INSTRUCTION TO SERVICE

ITS: 5161	
SECTION:	260 Battery Compartment and Power Distribution
WRITTEN BY:	Shaun Cardinal
SUBJECT:	UCAP Circuit Board Cover

ITS5161

Fig 14 – LF-MT-2001 Drill Jig Location Reference

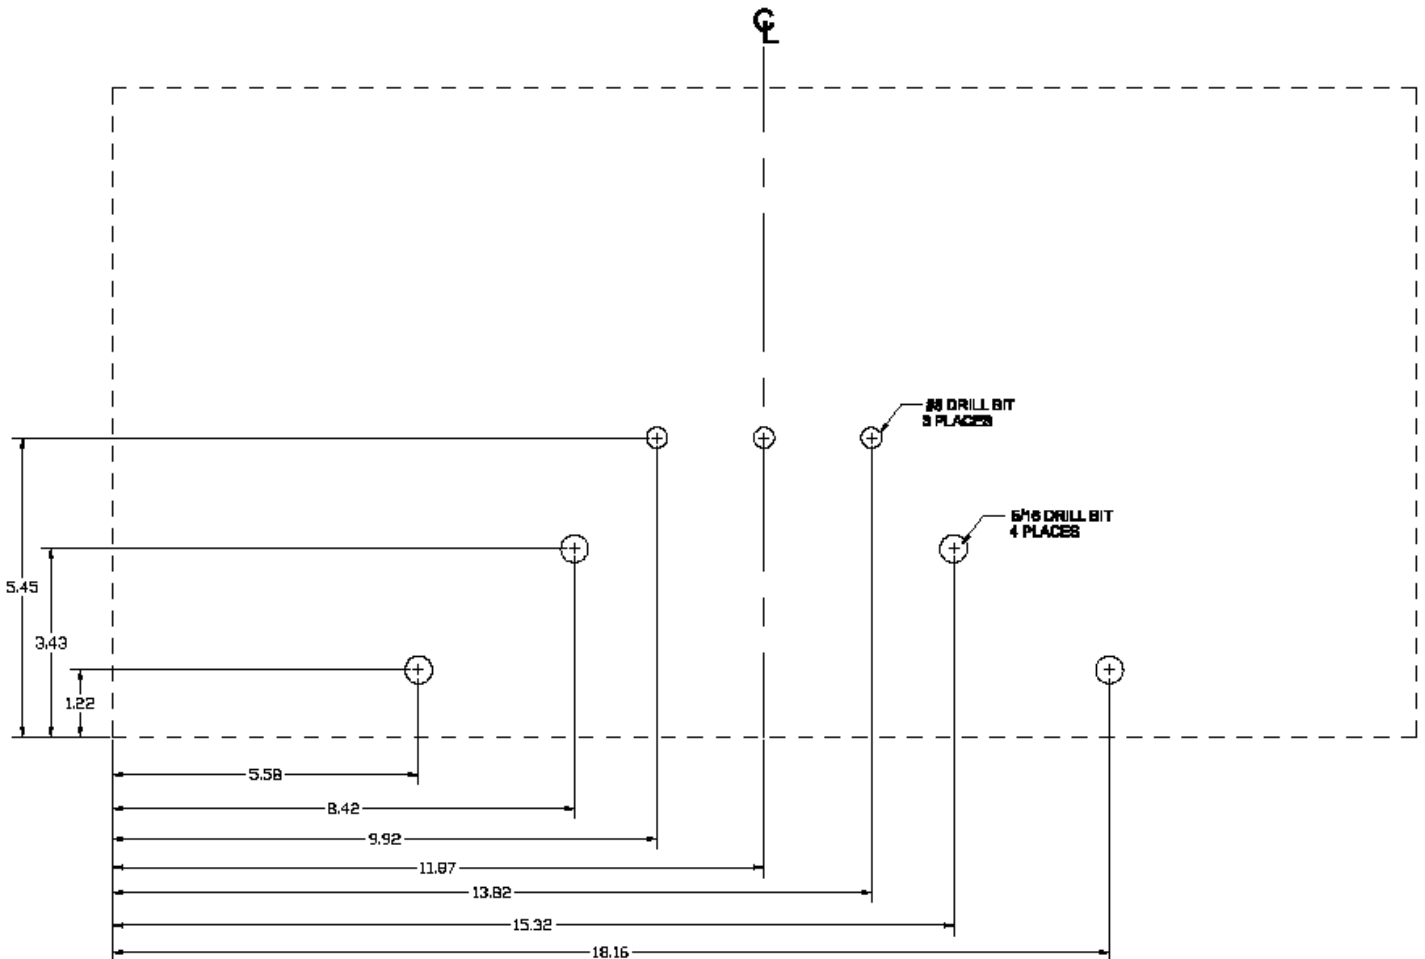
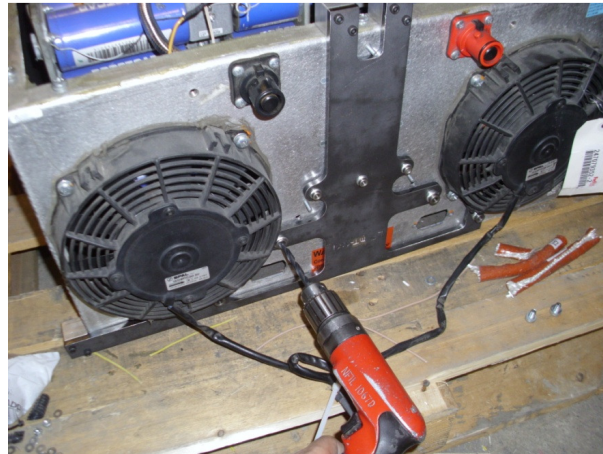
- g. For Mono Style UCAP's, remove 6x mounting hardware (See Fig 2) to allow the UCAP to tilt up. Use a block of 4x4 wood or equivalent to prop up (allowing jig to sit per Fig 14). Using the LF-MT-2001 drill jig, drill out the holes to secure the circuit board cover. Clean out any debris left inside the box (potential for short circuits/faults). Ensure locating surfaces of the jig are free of silicone/debris. See Fig 14.

Fig 16 – Sealed circuit board box/door

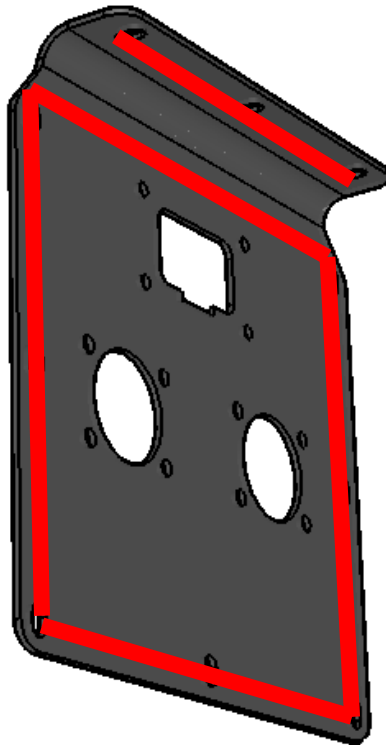
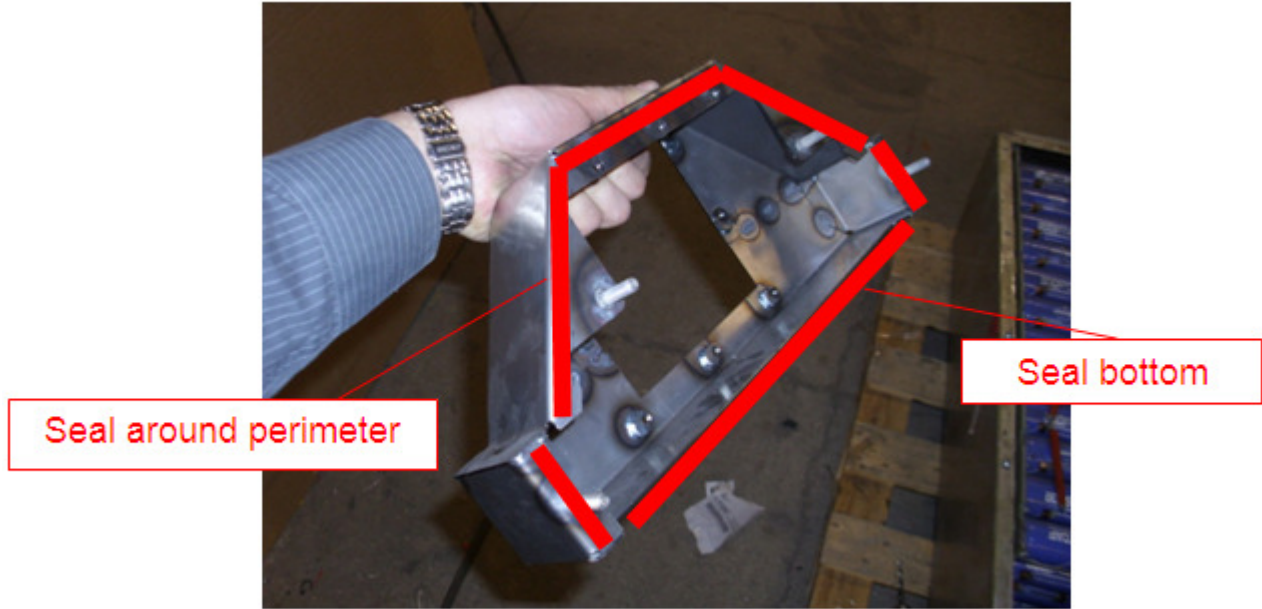
- i. Assemble the circuit board enclosure box (**NFI PN 469229**) and door (**NFI PN 468996**) by adding seal **NFI PN 5964906** per Fig 16

Fig 17 – Installed box

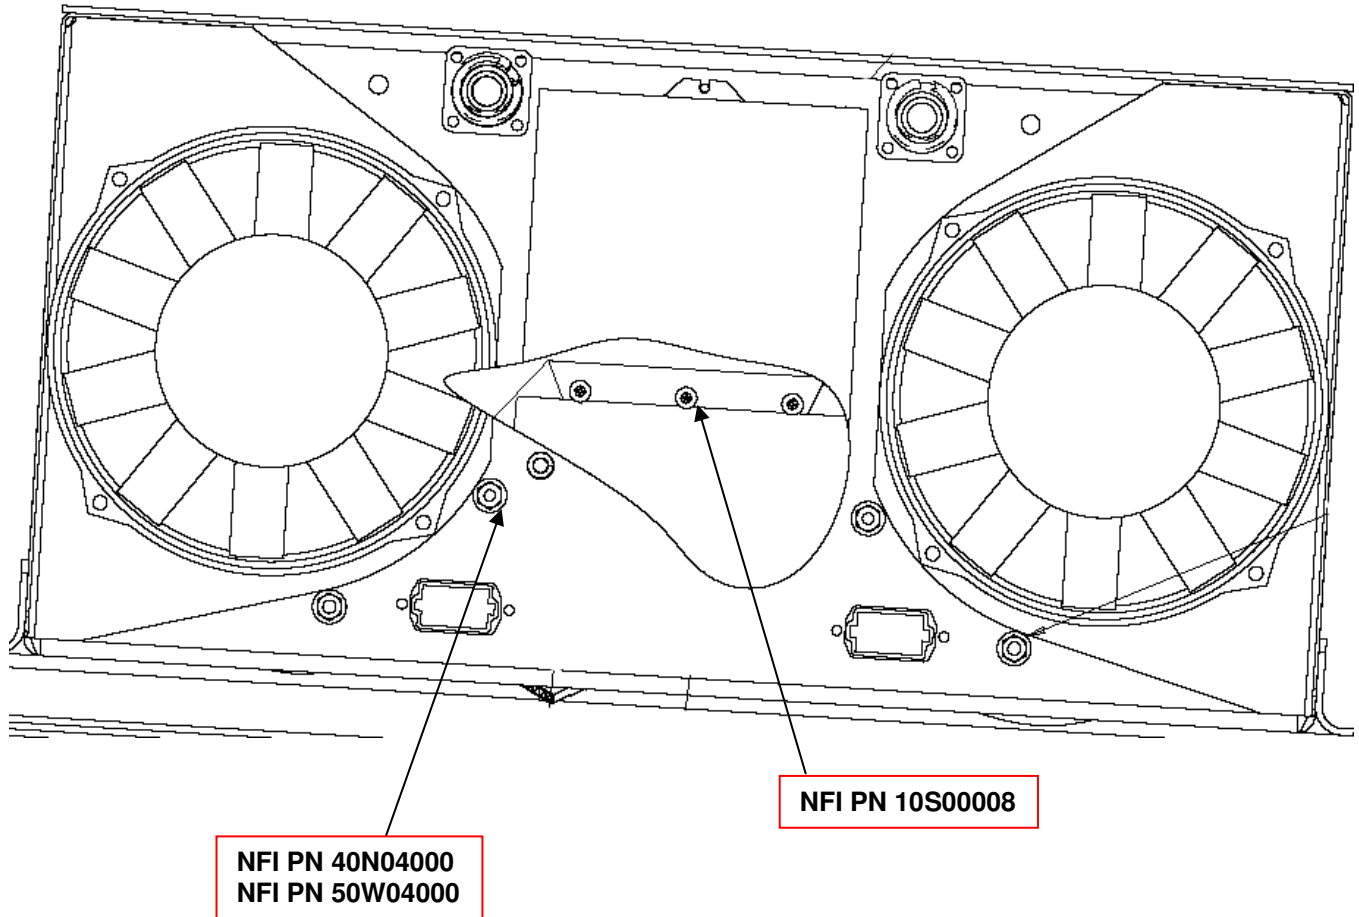
- j. Install the cover over top of the circuit board inside the UCAP box and secure with three **NFI PN 10S00008** recess screws, four **NFI PN 40N04000** 1/4-20 lock nuts, and four **NFI PN 50W04000** washers.

Fig 18 – Door Assembly

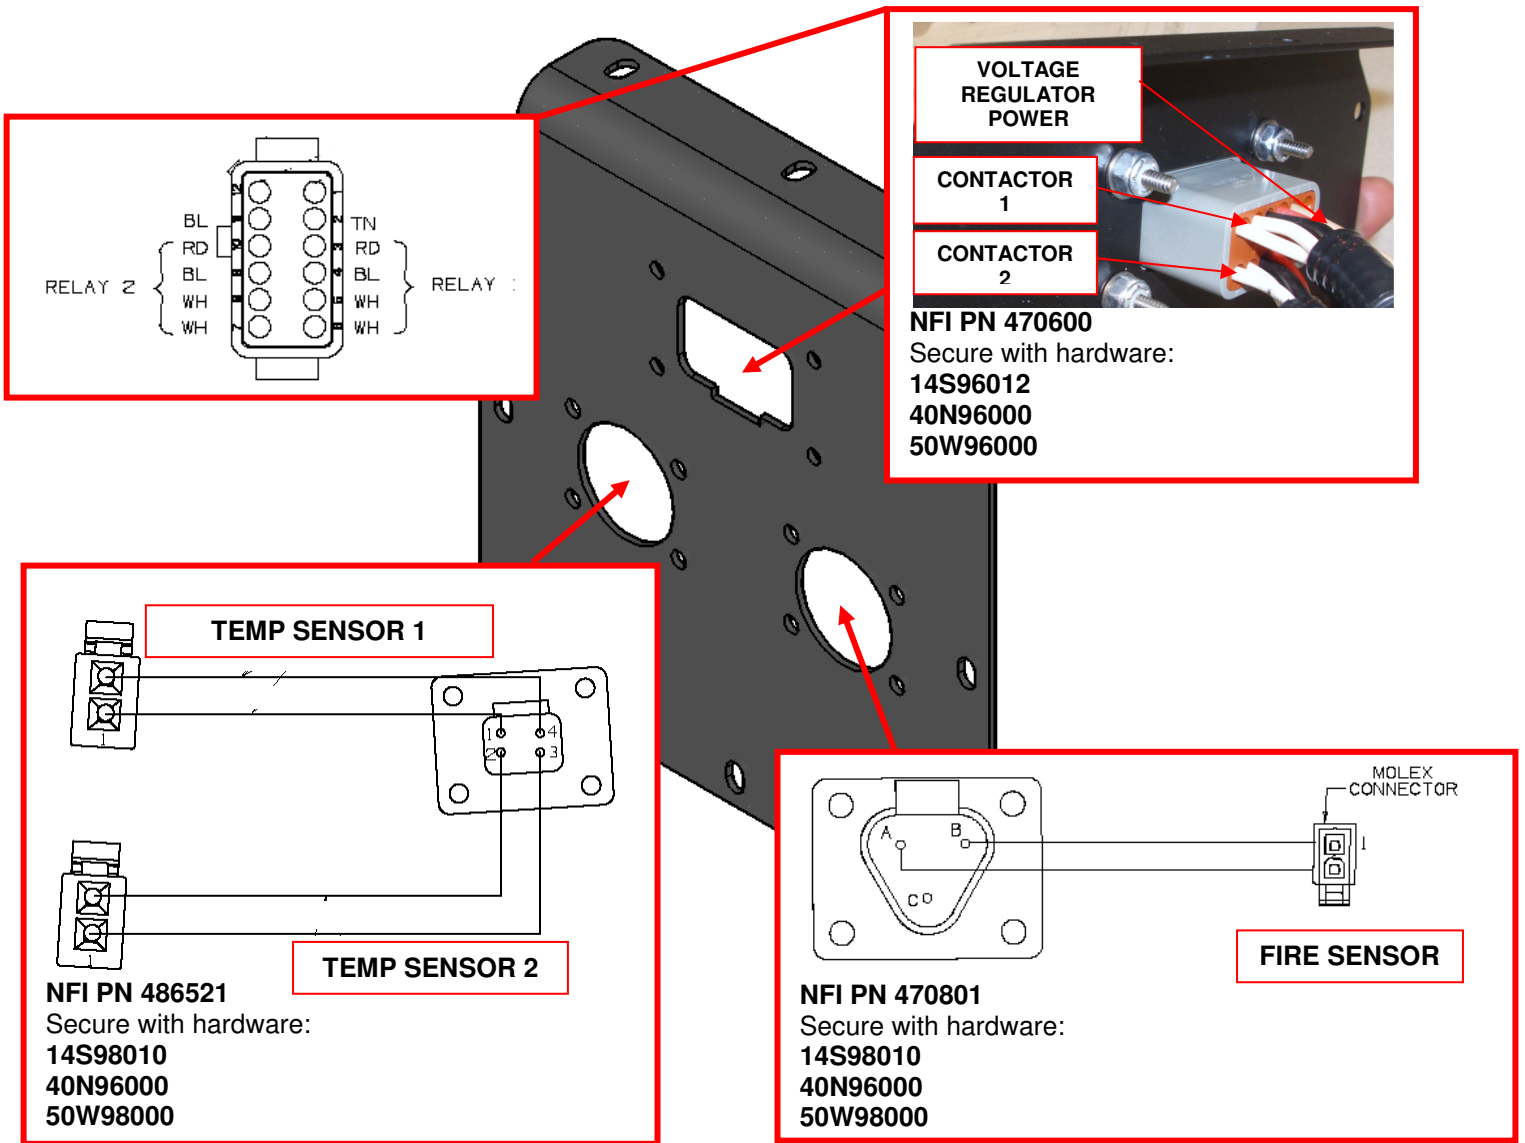
- k. Assemble door (NFI PN 468996) with harnesses **NFI PN 486521** and **NFI PN 470801** using hardware **NFI PN's 14S98010, 40N96000, and 50W98000** to secure. Install harness **NFI PN 470600** with hardware **NFI PN's 14S96012, 40N96000, and 50W96000**. See Fig 18.

Fig 19 – Adapter harnesses for door assembly

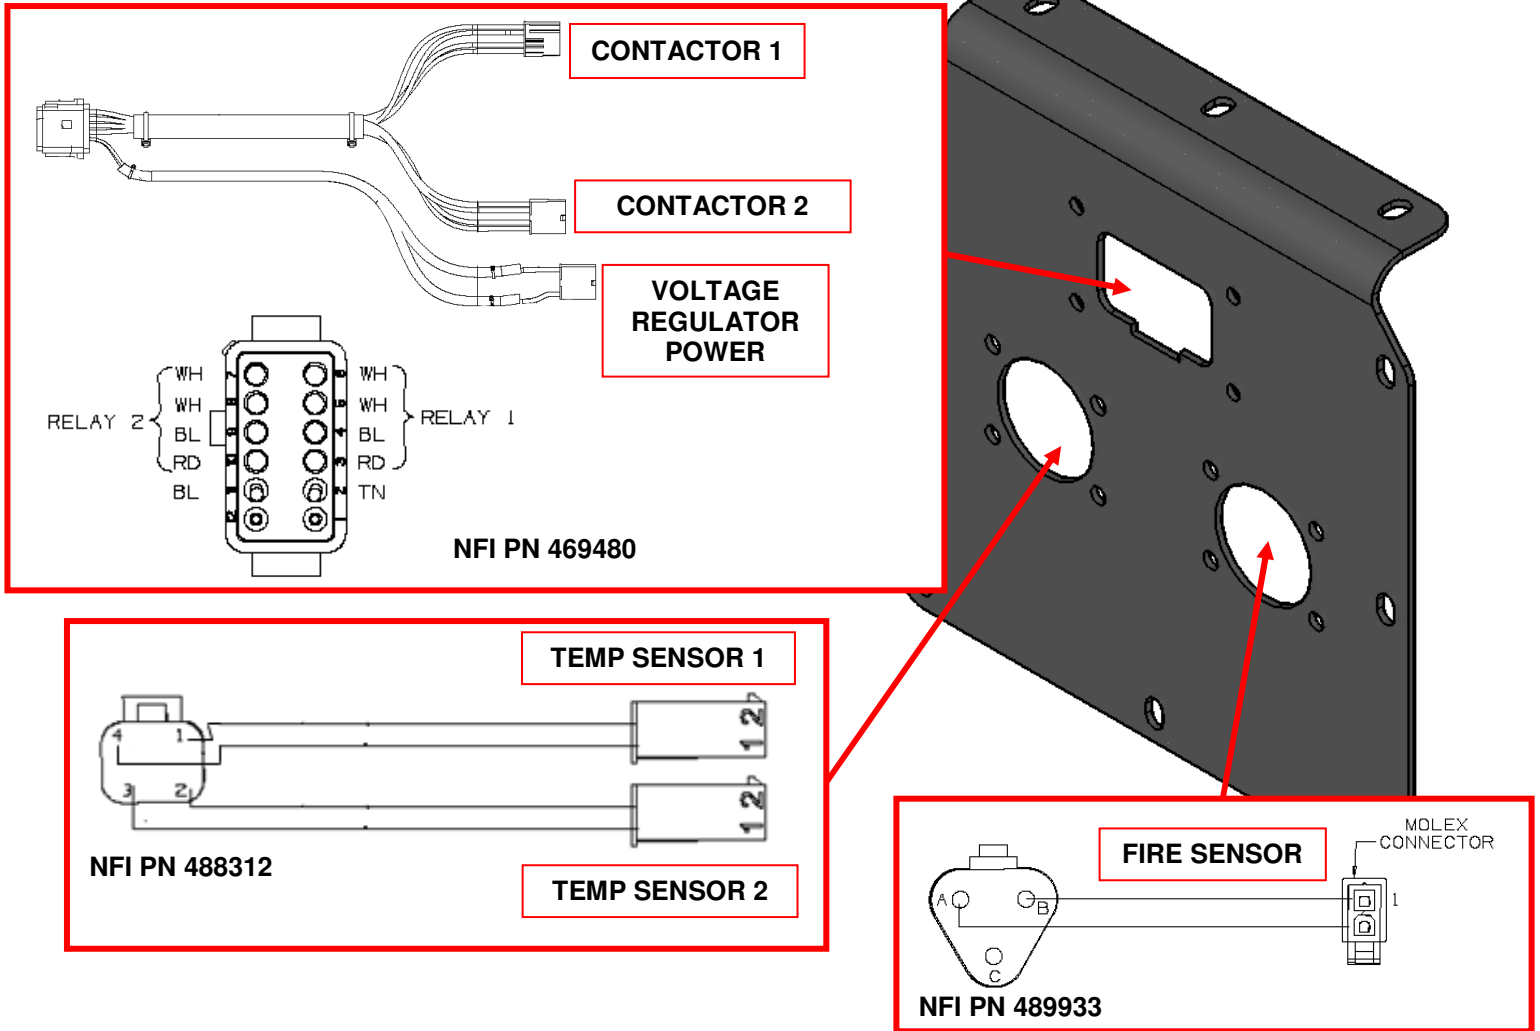
- l. Plug in Temp Sensor 1 and 2 harness **NFI PN 488312** into door assembly. Reconnect Temp Sensors. See Fig 19
- m. Plug in the Fire Sensor adapter harness **NFI PN 489933** into the existing fire bottle/fan cross harness. See Fig 19
- n. Plug in Contactor and Voltage Regulator Power adapter harness **NFI PN 469480** into existing Relays and Voltage Regulator Power harnesses. See Fig 19

Fig 20 – Fan Harness Extension

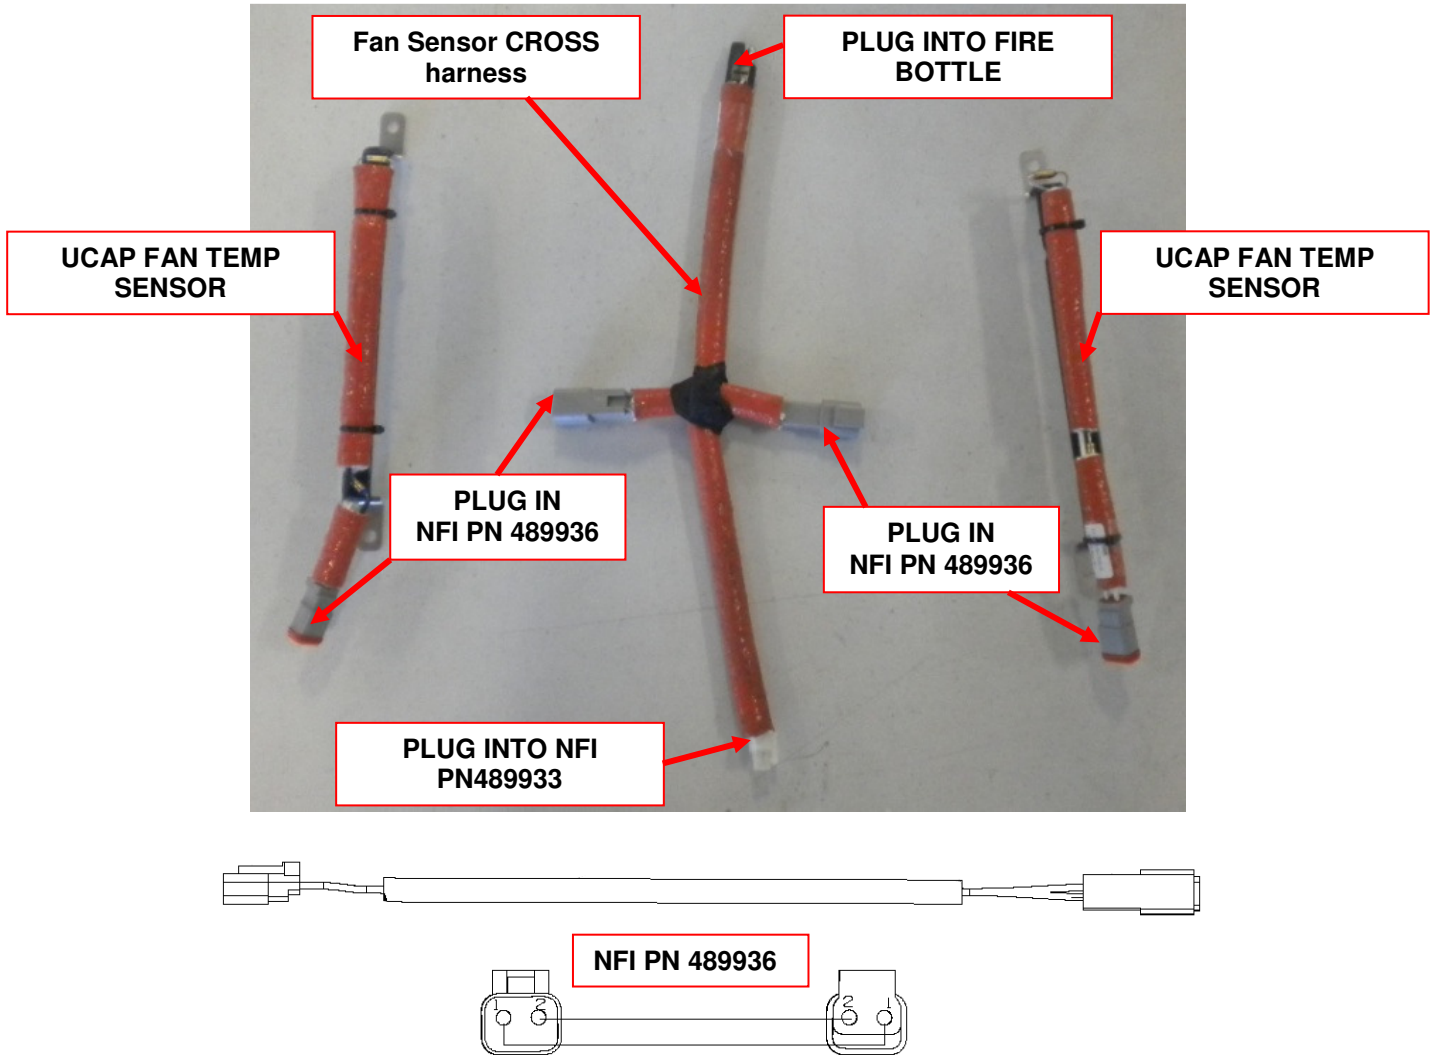
- o. To allow the UCAP fans to be connected (2x per UCAP), plug the Fan Harness extension harnesses NFI PN 489936 on each side of the Fire Sensor CROSS harness. See Fig 20
